## **MEETING NOTICE**

**Tuesday, May 27, 2025**

# SITE DEVELOPMENT PLANS FOR OSCAR'S CUSTARD 21165 EAST MORELAND BOULEVARD WAUKESHA, WI

Strand Associates, Inc.® (Strand) has finished its initial review of the plan package for the Oscar's Custard Redevelopment that was received from the Town on April 22, 2025, for conformance with the Town specifications and general engineering practices. Before construction may begin, the contractor shall submit all required permits for the redevelopment to the state, Wisconsin Department of Natural Resources, Town, and any other relevant agencies. New drawings and a letter describing the revisions should be returned to Strand after the following concerns have been addressed.

© COPYRIGHT 2025 R.A. Smith, Inc.
DATE: 04/30/2025
SCALE: 1" = 20'
JOB NO. 3240290
PROJECT MANAGER: CHRISTOPHER WHITE, P.E.
DESIGNED BY: CBW
CHECKED BY: MAF
<b>SHEET NUMBER</b>
C200

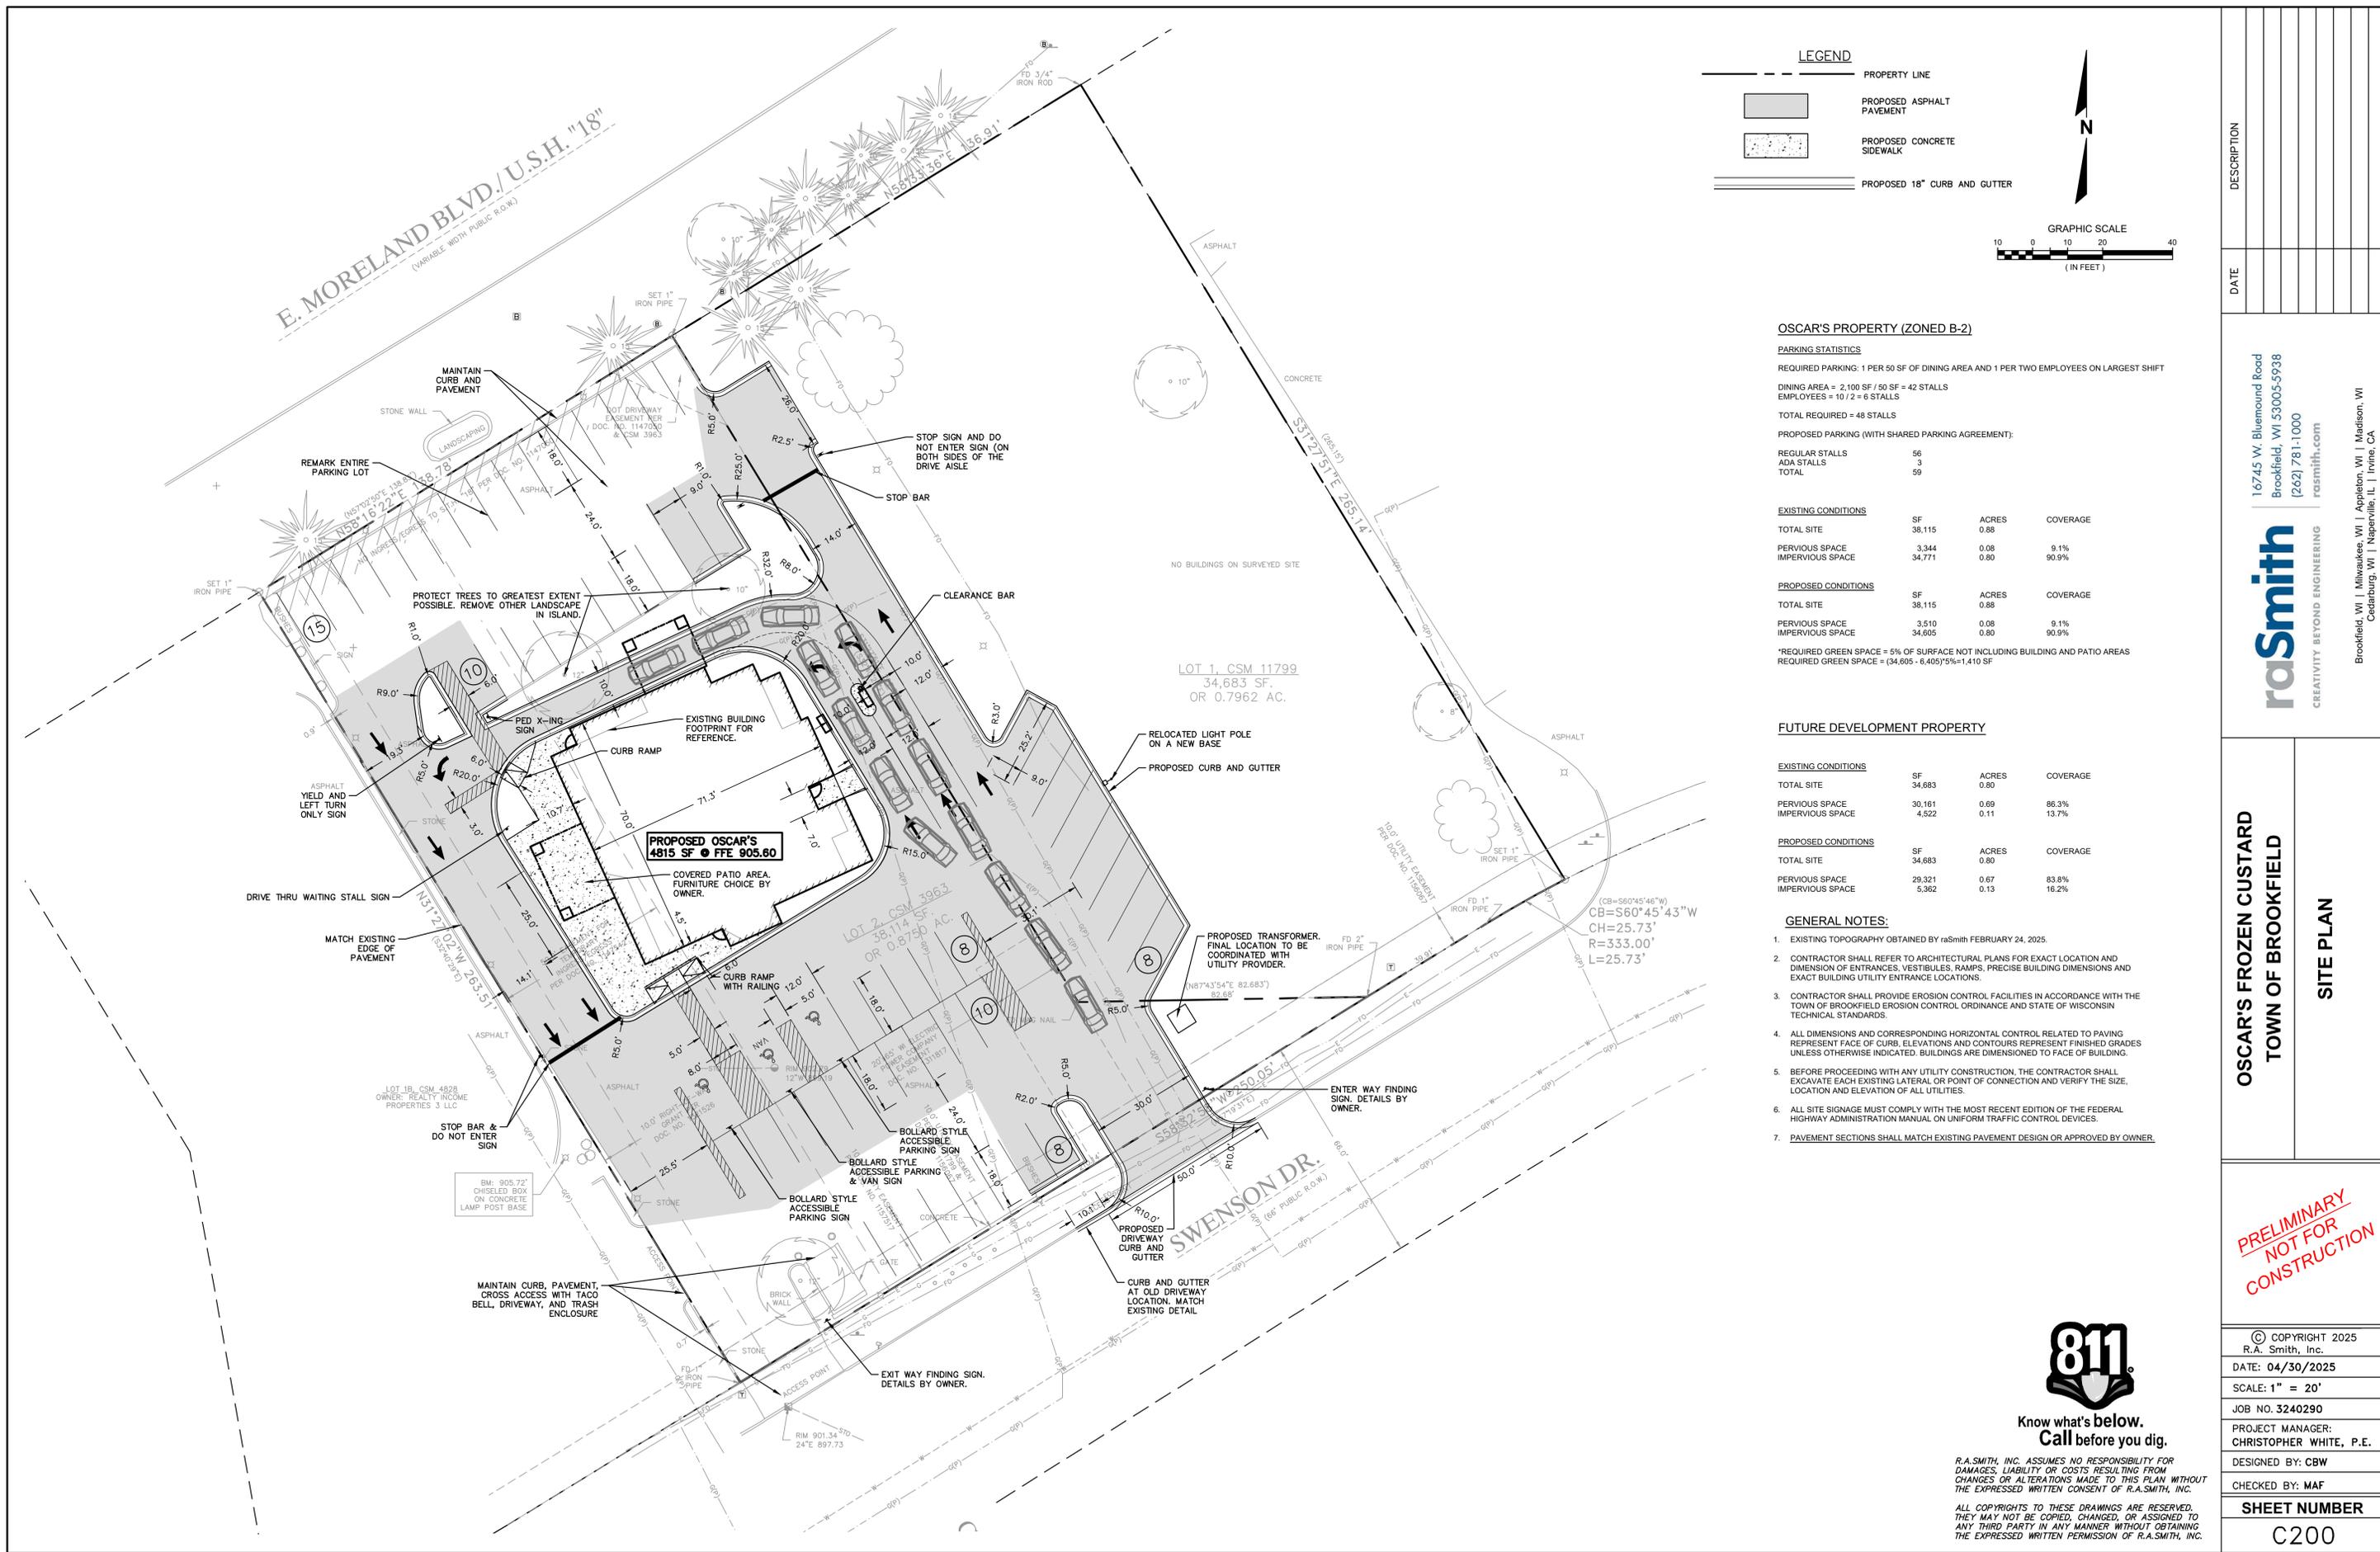
#### **Site Plan–Sheet C200**

1. Provide details on the proposed asphalt pavement and concrete sidewalk thickness.
2. Pavement marking arrows should be provided on the eastern driveway entrance to indicate whether this is only an entrance driveway or an entrance and exit driveway.
3. Pavement marking arrows should be provided on the western driveway entrance to indicate whether this is only an exit driveway or an entrance and exit driveway.
4. It is not clear whether the sidewalk on the east side of the proposed building is an entrance for customers or a private entry for employees. Regardless, there is no crosswalk pavement marking for safe access to the parking lot.

5. It should be verified that there is sufficient space for four waiting vehicles at each drive-through service lane in accordance with Section 17.06(3)(h)2.i of the Town Zoning Code.
6. Provide signage or pavement marking to discourage vehicles from using the space that will become the access into Lot 1 in the future.

1. Provide details on the proposed asphalt pavement and concrete sidewalk thickness.

**raSmith Response No. 1. – Site Plan: Proposed asphalt pavement and concrete sidewalk thickness have been shown on the details sheet C600.**

**raSmith Response No. 2. – Site Plan: The eastern driveway is proposed to be an entrance only driveway and pavement marking arrows have been added to sheet C200.**

**raSmith Response No. 3. – Site Plan: The western driveway is proposed to be an entrance and exit driveway to uphold cross access agreements. The pavement markings have been added to sheet C200.**

**raSmith Response No. 4. – Site Plan: The sidewalk on the east side of the proposed building is a delivery door that will be accessed for after hour deliveries. A crosswalk to this location is unnecessary since the delivery truck will make deliveries here when the restaurant is closed. The door will not be used during regular business hours. A note has been added to the site plan on sheet C200.**

**raSmith Response No. 5. – Site Plan: There is enough space for at least four vehicles to wait in each drive thru lane. An additional car sketch was added to the inner lane to show four vehicles waiting to order. The change can be seen on the site plan on sheet C200.**

**raSmith Response No. 6. – Site Plan: Two Temporary End of Road signs have been added to the site plan on sheet C200 the WisDOT sign detail has been added to sheet C501.**
